**TO:** Karen Keesecker, Planning Department

**FROM:** Scott R. Wheaton, Watershed Scientist  
Watershed Management Services

**SUBJECT:** Legacy Pointe Subdivision (Forest Heights LLC) Watercourses

Figure 1: Legacy Pointe (Forest Heights LLC) Vicinity

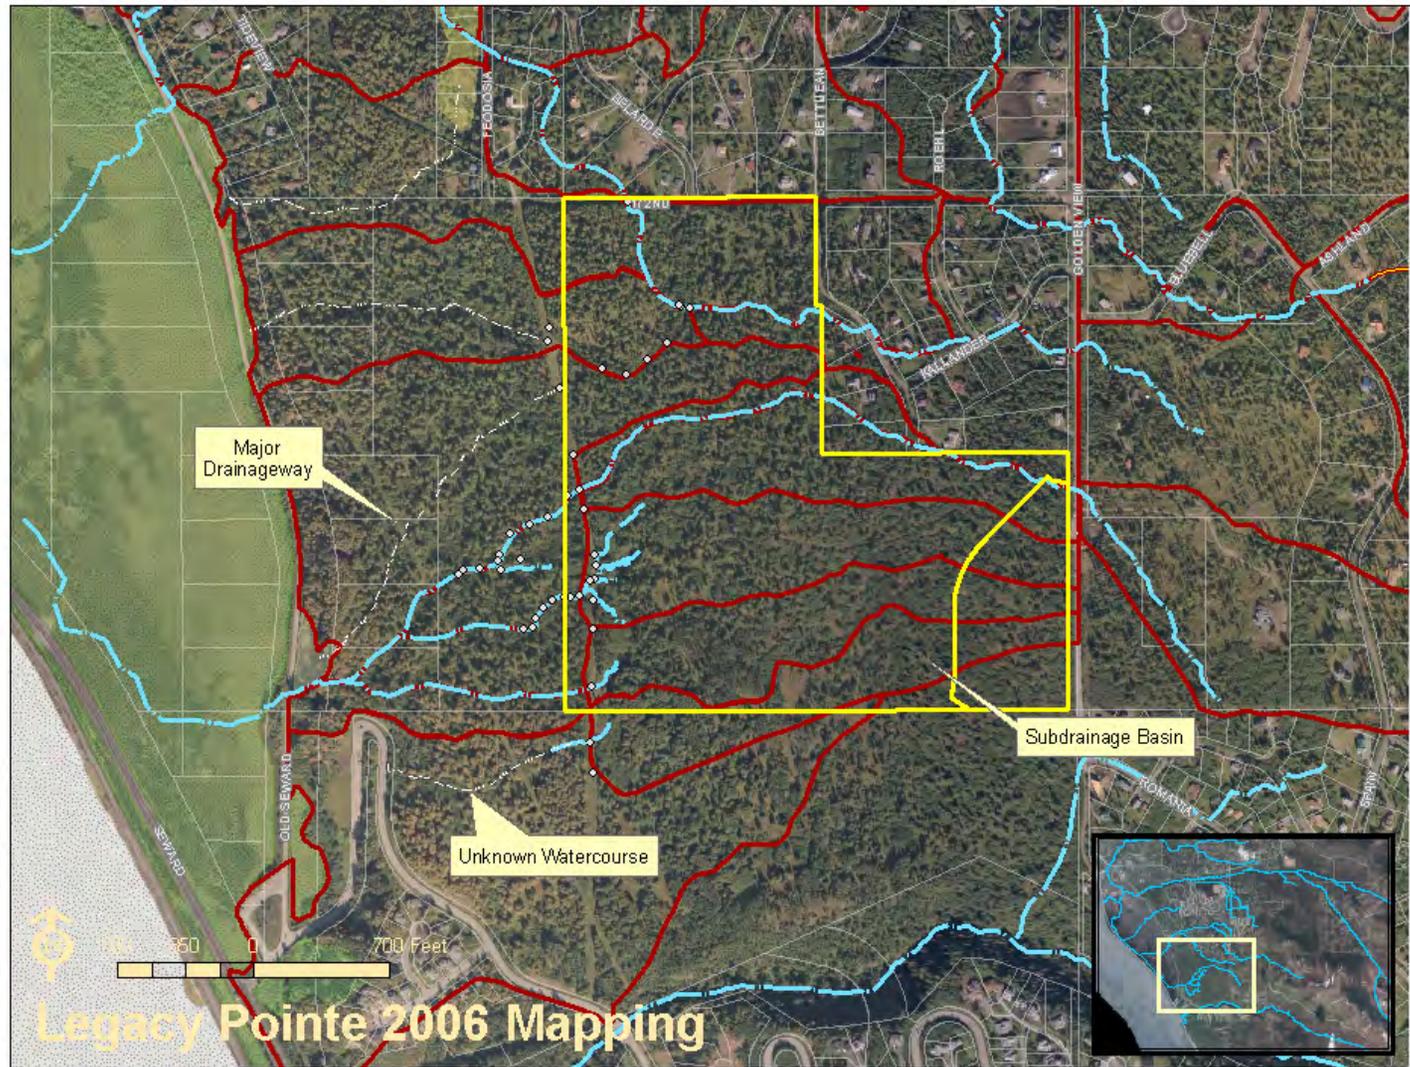
Natural drainage across Legacy Pointe is divergent, spreading out runoff from this area across a large downstream drainage area (Figure 1). Development (including construction of roads

typically across the fall line) will tend to concentrate runoff and focus it to fewer subdrainage basins. Careful consideration should be given to how runoff flows are combined to avoid intensification of downstream impacts or focus of flows into more sensitive drainages.

Figure 2: Legacy Pointe (Forest Heights LLC) Watercourses

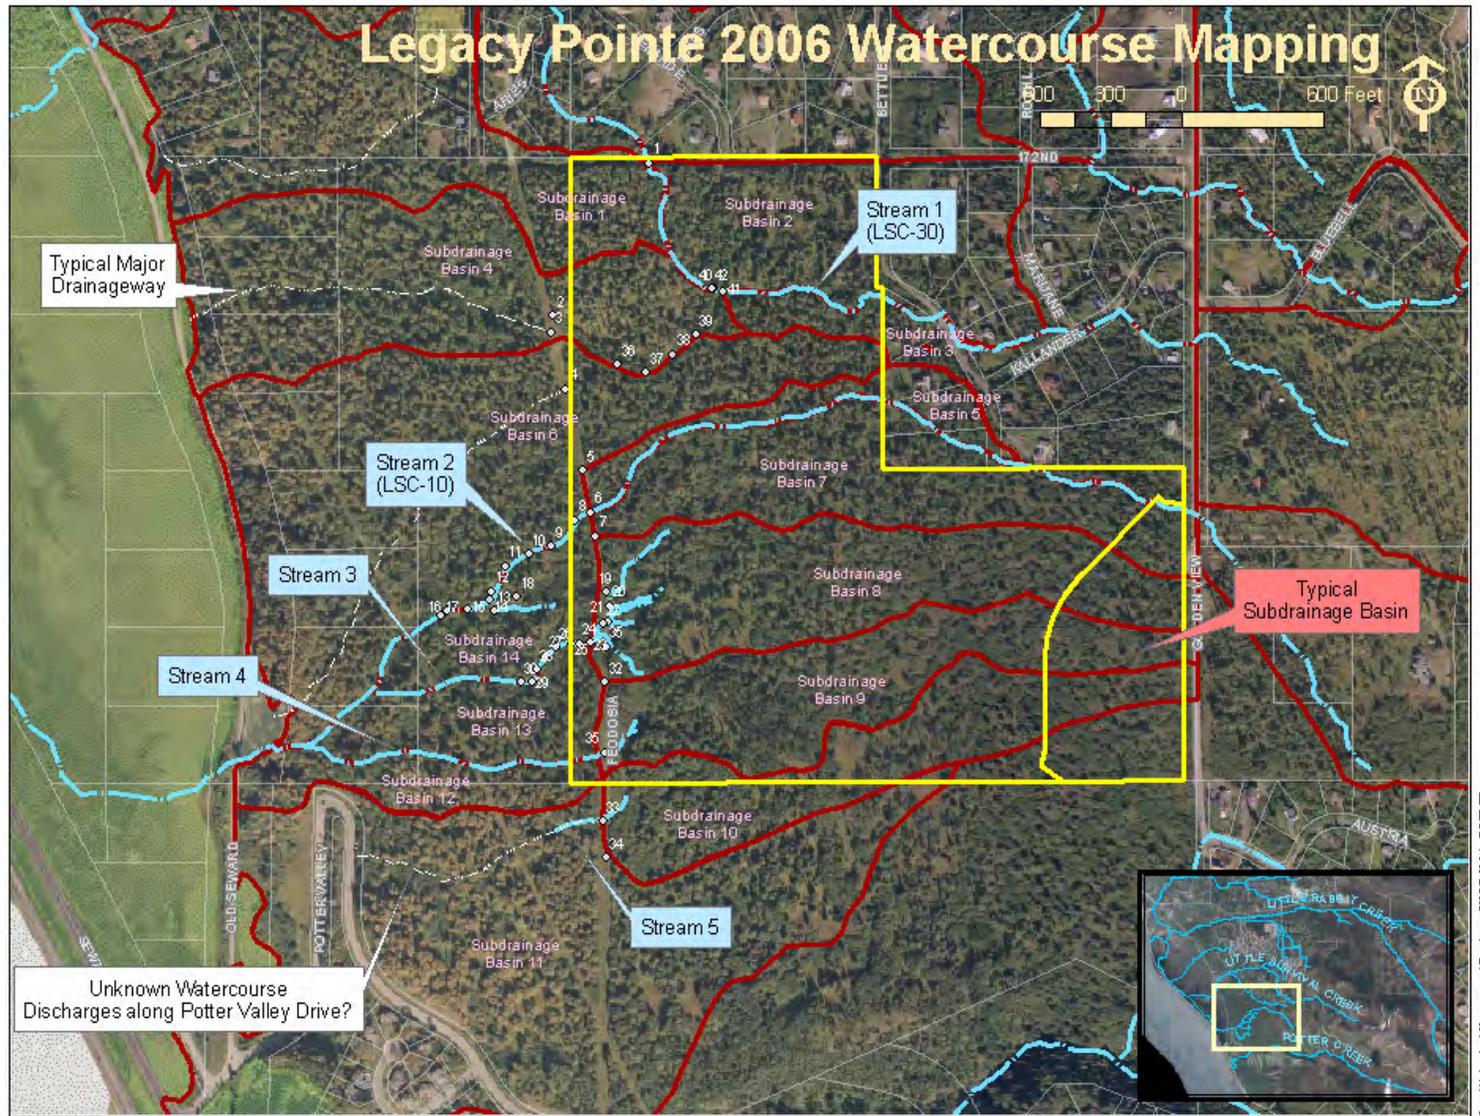
Subdrainage basins 10 and 11 and the southernmost watercourse/stream feature exiting Legacy Pointe (stream 5) appear to drain to the ditch along Potter Valley Drive (location of this drainage will be confirmed this late fall or next early spring). In addition to the potential impacts identified above, inadequately controlled post-development peak flows directed through this drainage system could also significantly impact Potter Valley Drive drainage and road systems through erosion, sedimentation and icing problems. (Also note that in order to divert flows directly to Potter Creek, the discharge point from Legacy Pointe would have to be located about 1500 feet above the western boundary of the subdivision or diversion ditching would have to be constructed outside the property boundaries.)

Finally, LIDAR-generated MOA 4-foot contour mapping was not consistent with field mapping results. Steep-sided, deeply entrenched watercourses mapped in the field are not expressed in MOA's 4-foot contour mapping. Rather post-processed LIDAR data appeared to interpret the top of the dense predominant devil's canopy as the last-return ground feature. Detailed design of controls for Legacy Pointe post-development peak storm water flows may require ground survey of downgradient flow lines in order to allow adequate assessment of hydrology and hydraulics.

Figure 3: Legacy Pointe (Forest Heights LLC) Drainage Pattern

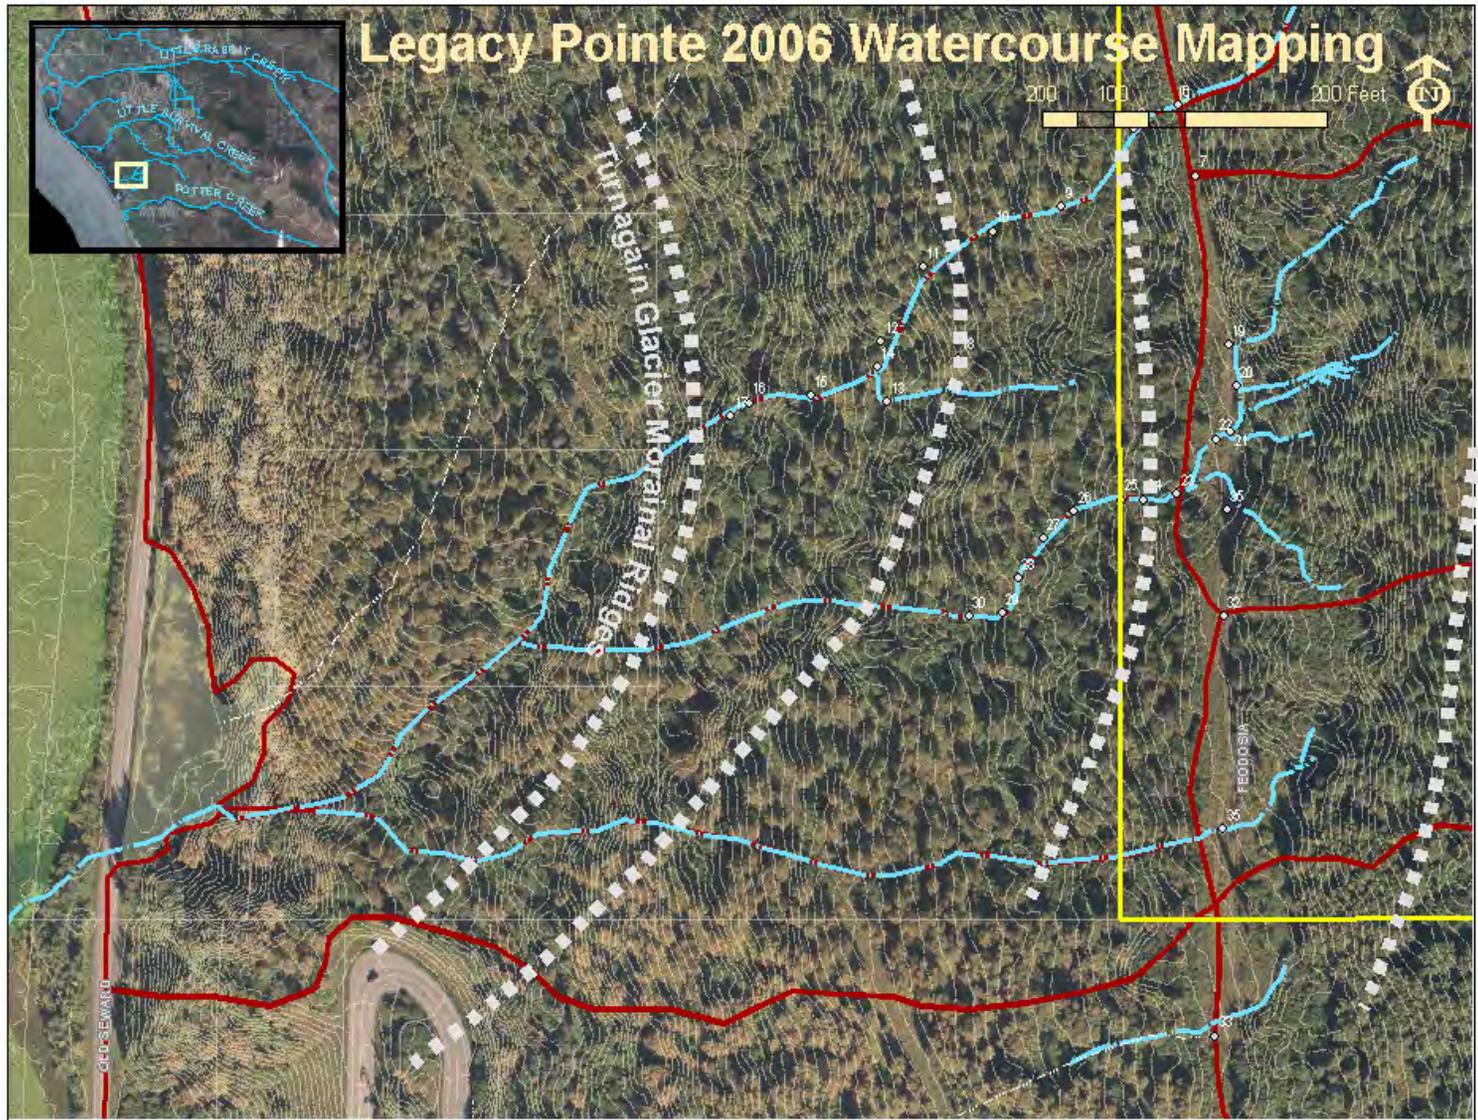
Downstream drainages cross a series of steep morainal ridges (Figure 3). Increased post-development peak flows directed across the steep faces of these ridges could dramatically increase erosion and associated sedimentation along the ridge surfaces and into Potter Marsh.

A major portion of Legacy Pointe drainage enters a convergent stream network. This convergent network will naturally focus all post-development flows that are directed into this small stream system. Timing of downstream peak flows are likely to be additive and should be explicitly addressed in designing peak flow controls.
